**FINAL ENGINEERING PLANS
FOR
SUMMIT HOUSING GROUP - MULTIFAMILY SITE**

TRACT A, BLOCK 3

LYONS VALLEY PARK FILING NO. 8

COVER SHEET
SUMMIT HOUSING GROUP
LYONS VALLEY PARK FILING NO. 8
LYONS, COLORADO

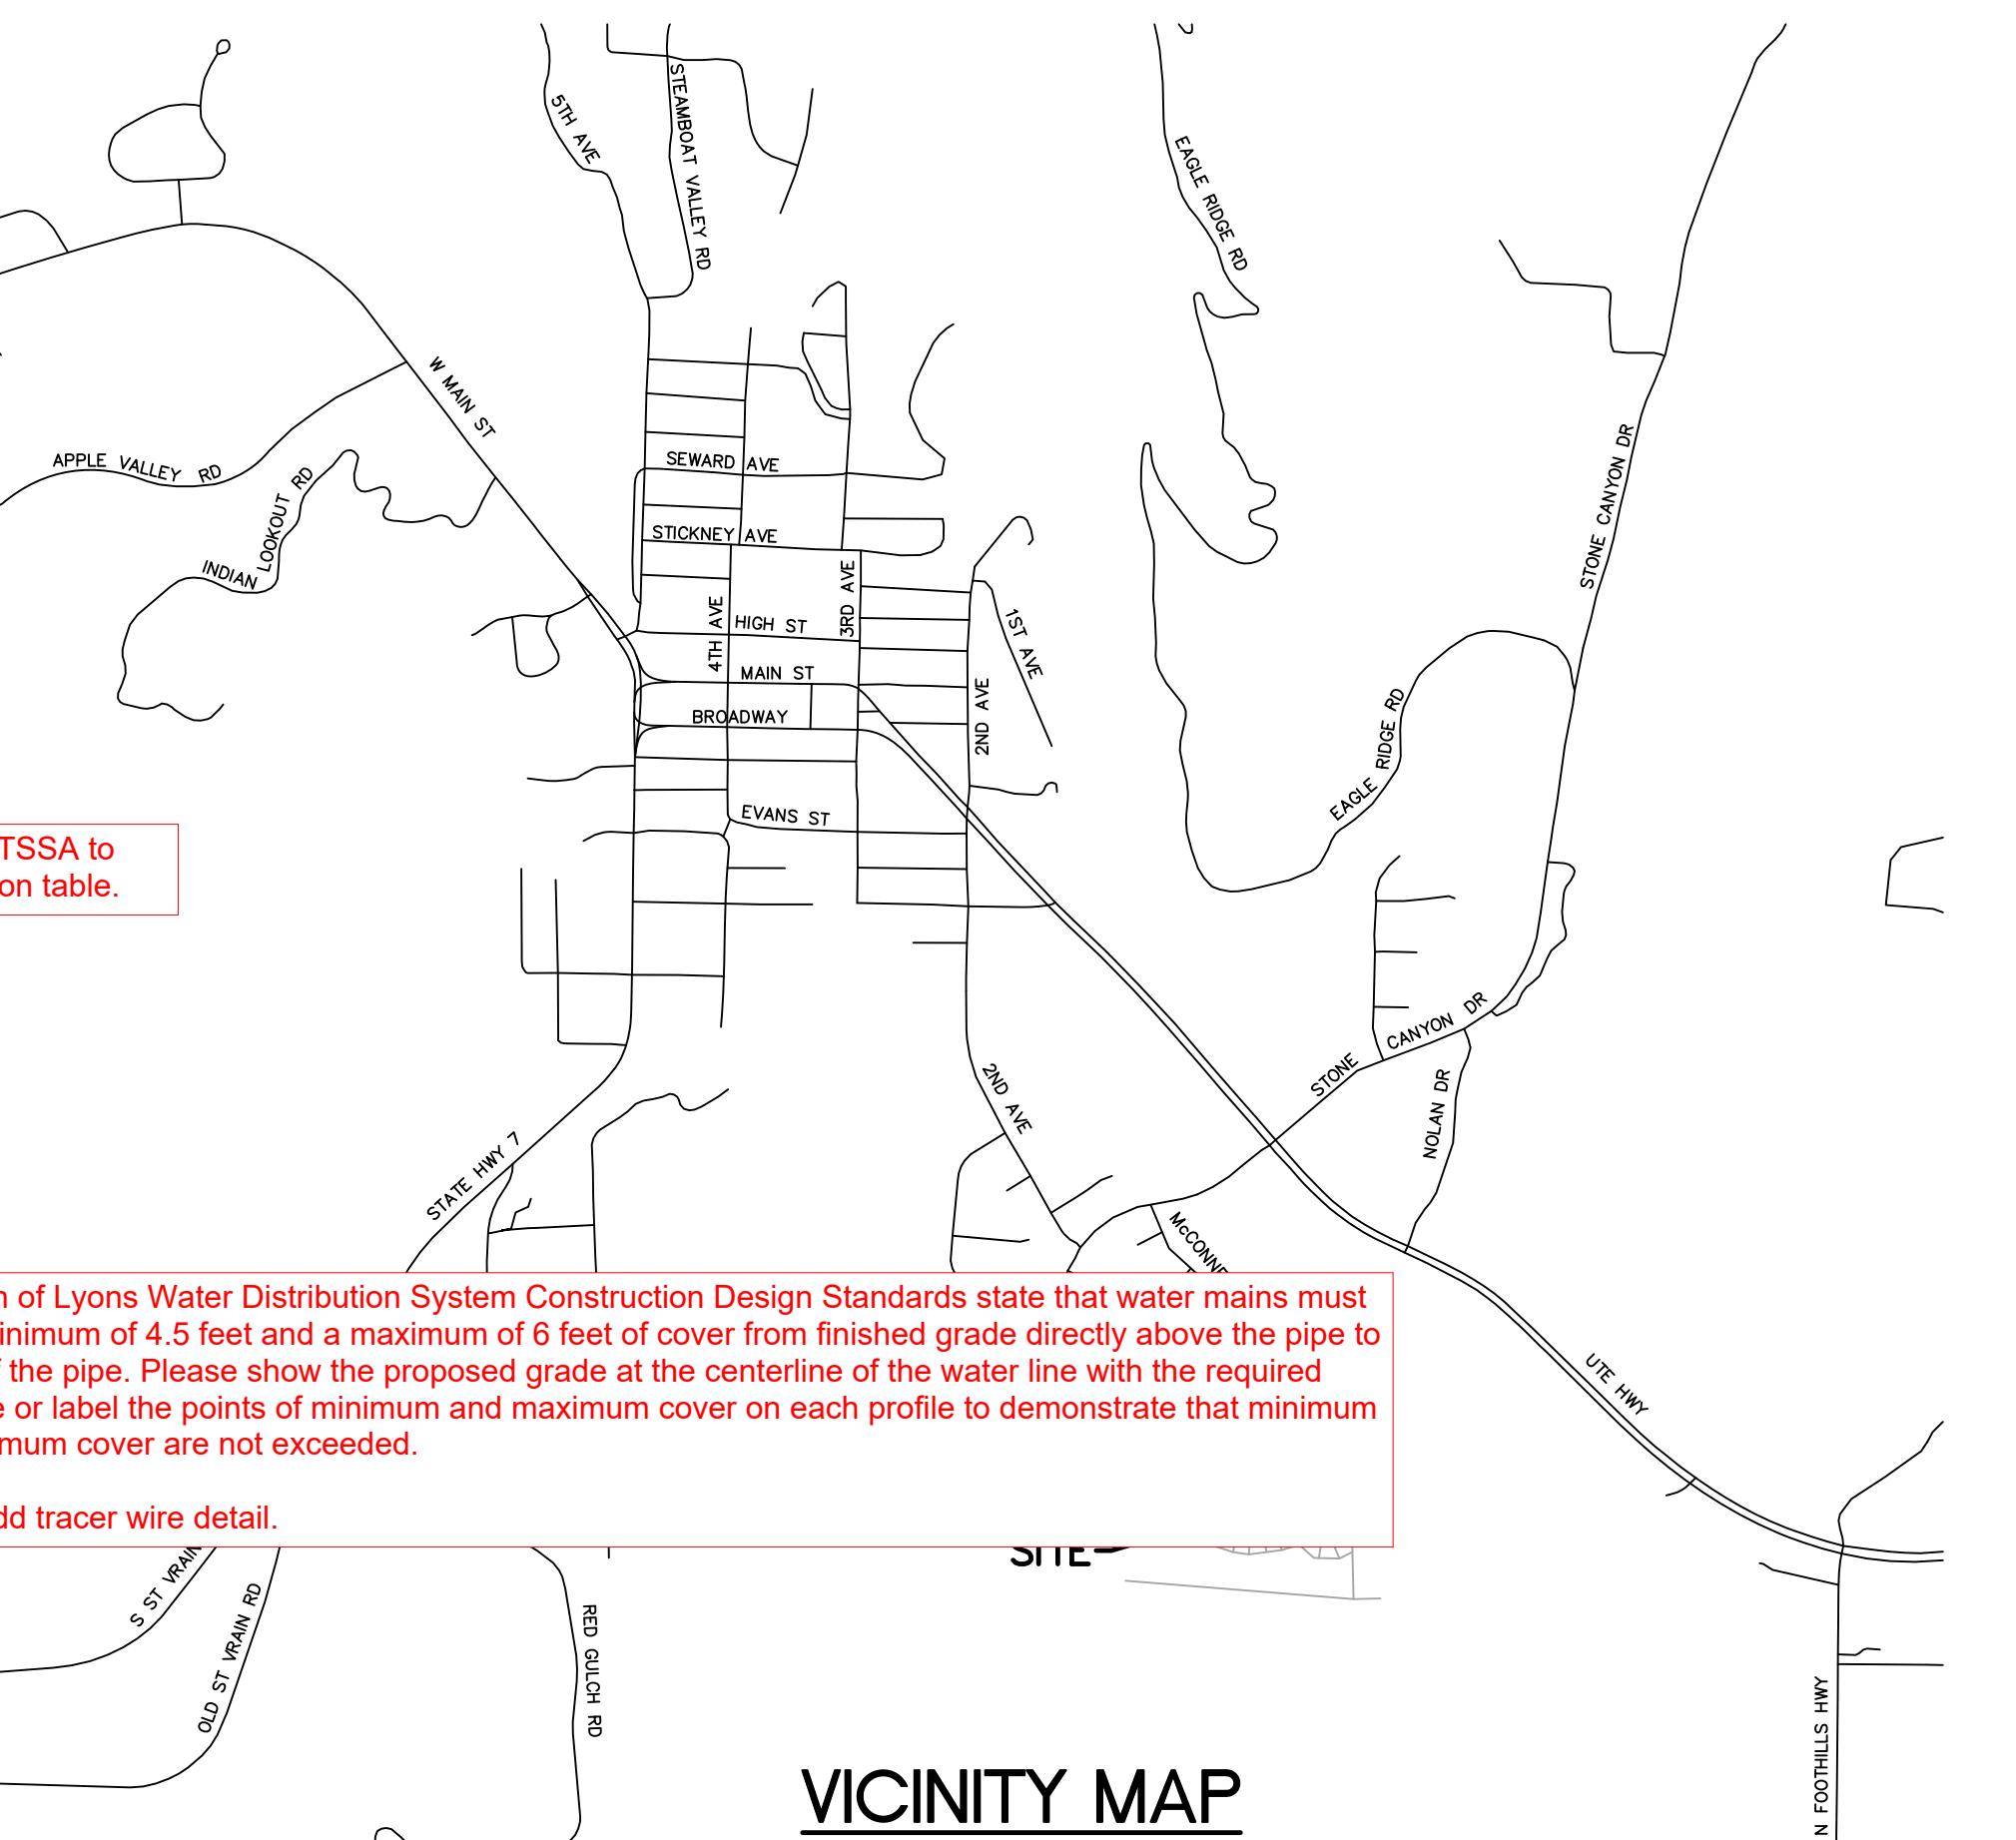
Please add the following note:
For PVC pipe, the curvature of the pipe shall be accomplished through longitudinal bending of the pipe barrel. Deflection of the joint is not allowed and may cause leakage. Confirm the minimum radius is met per manufacturer's requirements.

Please provide documentation on how the water quality capture volume is being achieved; how water quality treatment standards and requirements from CDHPE and/or MHFD (UDFCD) are being met utilizing the existing porous landscape detention area. This water quality/detention facility that was designed and documented in a drainage report 13 years ago, please confirm that the water quality BMPs using current MHFD standards are being met.

Please coordinate all Sheet Titles on individual sheets with Sheet Index.

Please include approval block.

Please provide signature.

Please define all hatching on cover sheet or on all individual sheets where hatching is shown.

Please provide symbol for sanitary manhole.

Please provide symbol for storm manhole.

EXISTING CONDITIONS SUMMIT HOUSING GROUP LYONS VALLEY PARK FILING NO. 8 LYONS, COLORADO

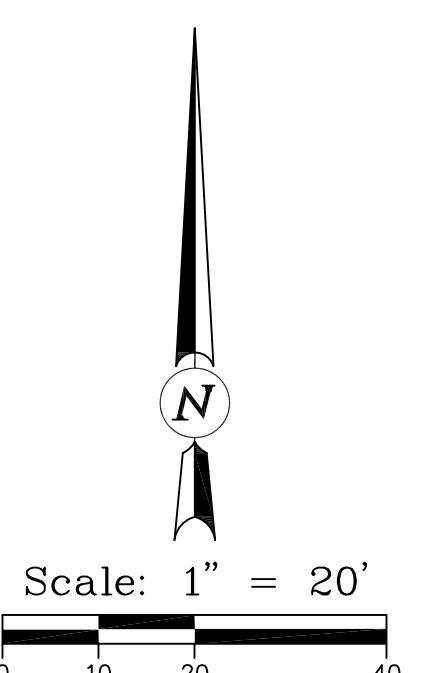
Currently, no
monuments are
shown. Please verify
this note is needed.
